CONTRACT NO. DE-AC27-01RV14136 – TRANSMITTAL OF U.S. DEPARTMENT OF ENERGY, OFFICE OF RIVER PROTECTION (ORP) DESIGN ASSESSMENT NUMBER D-07-DESIGN-040: REVIEW OF ALUMINUM ENTRAINMENT IN BECHTEL NATIONAL, INC.'S (BNIs) FEED RECEIPT AND EVAPORATOR SYSTEMS

**REVIEW OF ALUMINUM ENTRAINMENT  
IN BECHTEL NATIONAL, INC.'S  
FEED RECEIPT AND EVAPORATOR SYSTEMS**

**Design Oversight: D-07-DESIGN-040**

Figure 1. Impact of pH on Yield Stress (Calloway et al. 2004)

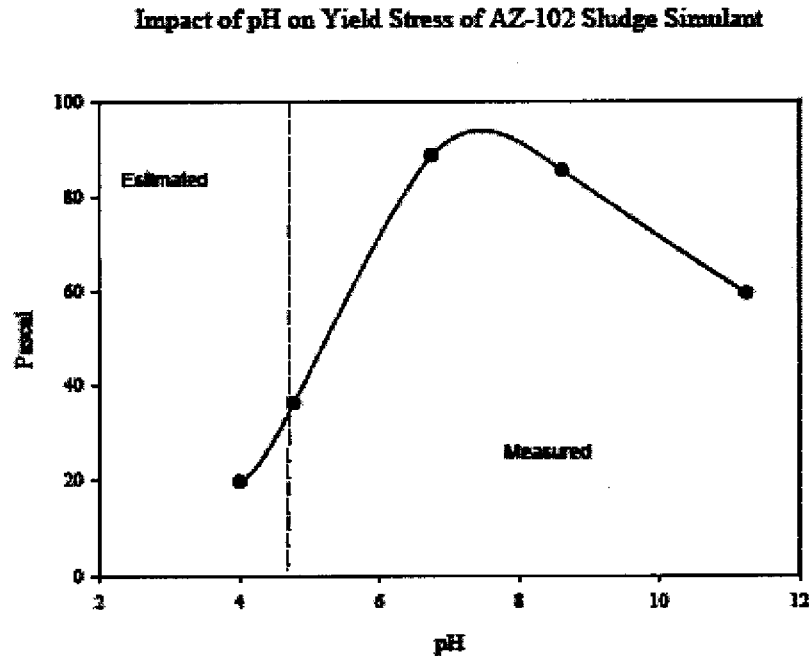
The absorption of CO<sub>2</sub> from ventilation, PJM mixing, or sparge air in the presence of aluminum or phosphate species will have an impact on the yield stress of waste slurries; see Figure 1.

As CO<sub>2</sub> is absorbed, the pH of the waste slurry will drop due to the formation of carbonic acid (H<sub>2</sub>CO<sub>3</sub>). In turn, aluminum (if present) will precipitate and the yield stress of the waste slurry will increase. The Oversight Team recognizes that Calloway et al. (2004) (Figure 1) will also be affected by waste slurry temperature.

Figure 2. Absorption of CO<sub>2</sub> Cycle

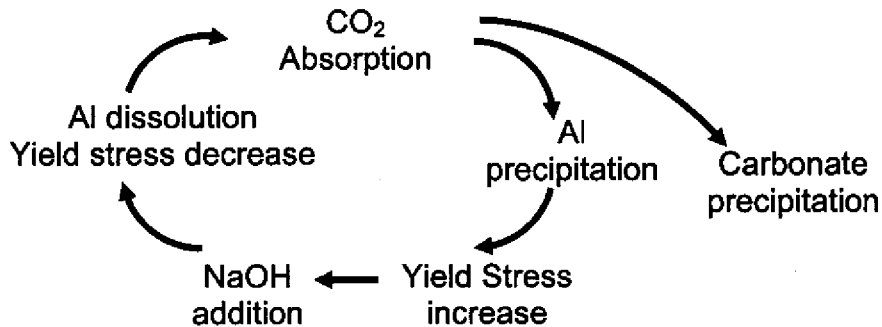
The absorption of CO<sub>2</sub> has been estimated at approximately 75% for waste slurries above 0.1 molar hydroxide (Hobbs 1987). The absorption of CO<sub>2</sub> at the high pH range in the PT Facility will result in a complex cycle: CO<sub>2</sub> → aluminum and carbonate precipitation → yield stress increase → NaOH addition → Al dissolution + yield stress decrease. This cycle is illustrated in the Figure 2.

The removal of CO<sub>2</sub> from the system will result from the precipitation of carbonates including metals and alkaline earths.

Figure 1. BNI Estimated Change in pH and [OH<sup>-</sup>] over 80 days in Vessel HLP28.

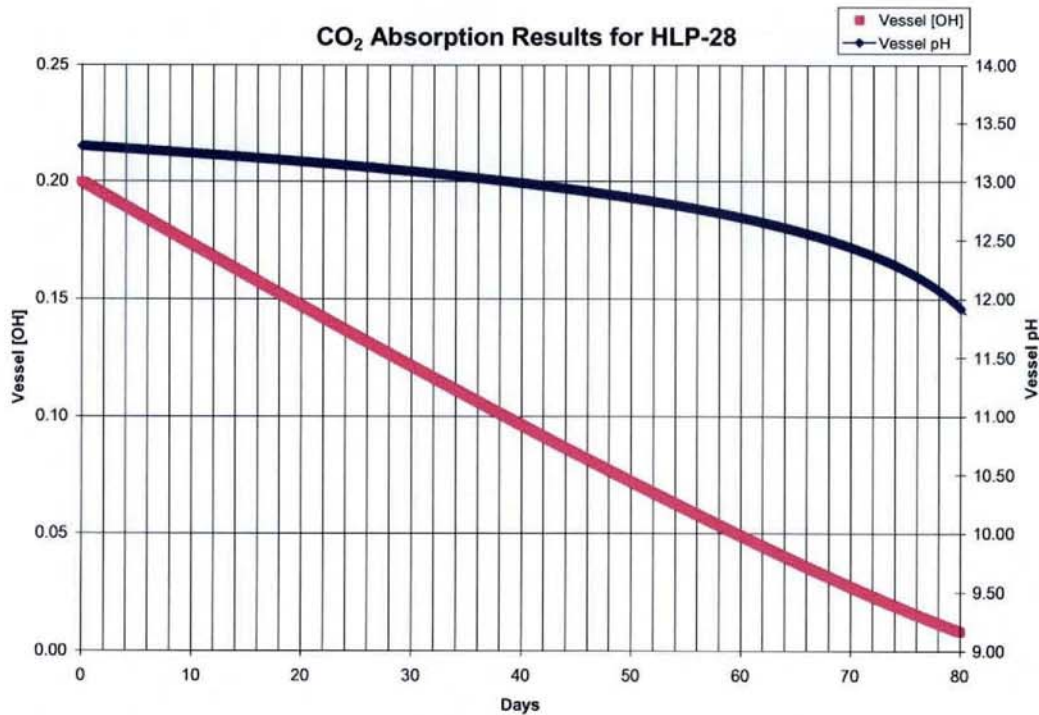
Vessel HLP-28 experiences the greatest airflow rate from spargers, therefore this vessel was used as a bounding case to demonstrate the effect of CO<sub>2</sub> on the pH of the waste. The change in CO<sub>2</sub> was calculated iteratively for each hour in an Excel spreadsheet. The Hobbs correlation was assumed to estimate absorption rate of CO<sub>2</sub> based on hydroxide concentration ([OH<sup>-</sup>]); this correlation is derived from observations of Savannah River tank waste exposed to CO<sub>2</sub> (Hobbs, 1987) and provides an expression to model CO<sub>2</sub> absorption rate as it linearly declines with [OH<sup>-</sup>]. Although this correlation was not derived from observations of Hanford tank waste, it is reasonable to use this correlation for an estimate since it is based solely on [OH<sup>-</sup>]<sup>1</sup>. Figure 1 graphically depicts the calculated change in vessel pH and [OH<sup>-</sup>] with time. Over 80 days, the pH is shown to decrease from 13.3 to 11.9 and approximately 0.19 M hydroxide is consumed.

The normal operating residence time in HLP 28 is designed to be approximately 30 days, therefore it was concluded that a nominal pH change would be experienced. This drop in pH was estimated to maximally require an additional 2% (66 gallons/day assuming a Hobbs coefficient of 1 (100% absorption of CO<sub>2</sub>)) of the total sodium hydroxide requirement to maintain an appropriately alkaline operating pH (pH = 13.3).

**Figure 7. Estimated Changes in pH and [OH<sup>-</sup>] over 100 Days in HLP28 (data from BNI) Compared to Solubility of Gibbsite ([Al<sup>3+</sup>]<sub>TOT</sub> = 1.0 M in H<sub>2</sub>O at 25 °C) over pH (ESP calculation); Al[OH]<sub>3</sub> Solids Precipitate in Shaded Region.**

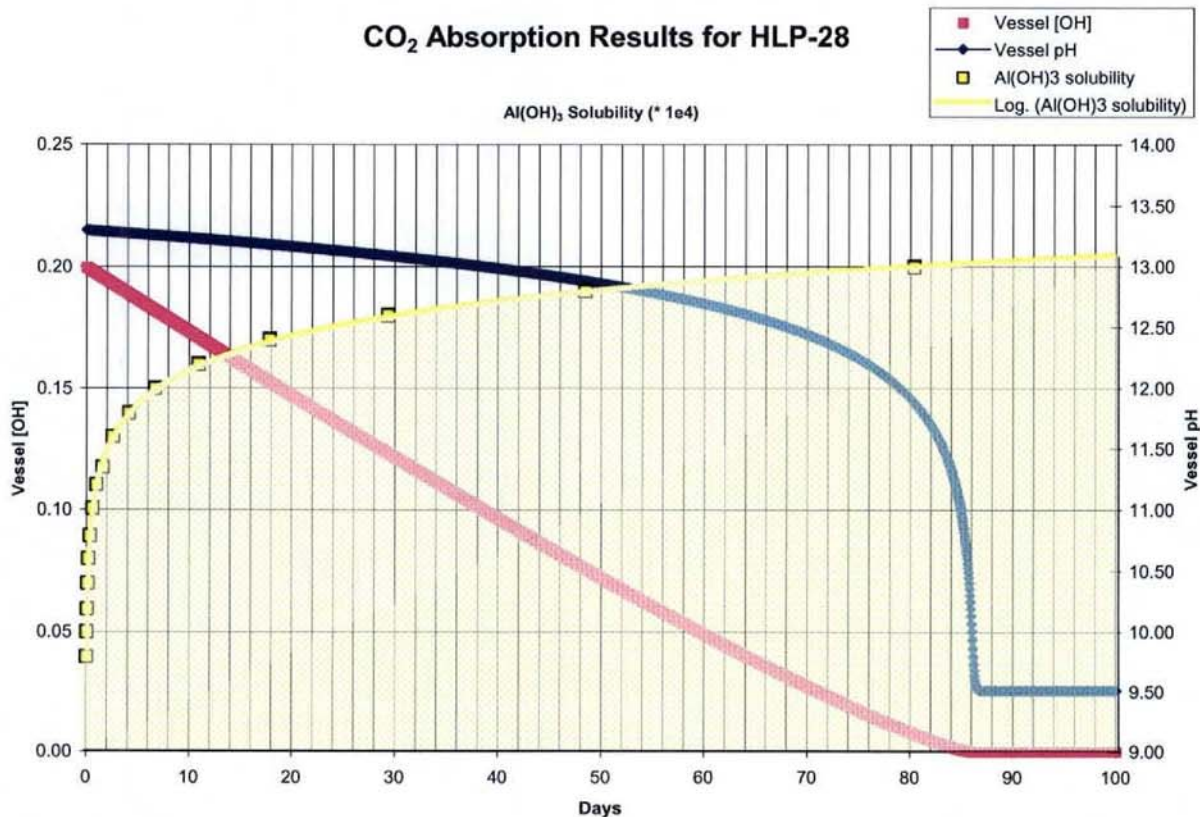
First, the pH must be maintained above 12.9. As shown in Figure 7, the decline in pH follows a modest slope in the highly alkaline range and can be maintained above the aluminum hydroxide precipitation region with small doses of caustic. If the pH is allowed to drift into the aluminum hydroxide precipitation region, particularly below a value of 12, pH does then have the potential to decrease drastically over a relatively short time period and much of the aluminum in solution would precipitate (dependent on total aluminum, temperature and ionic strength). It has been documented though that adequate provisions have been included to maintain an appropriately alkaline pH within all vessels in PTF (Alexander et al., 2007).
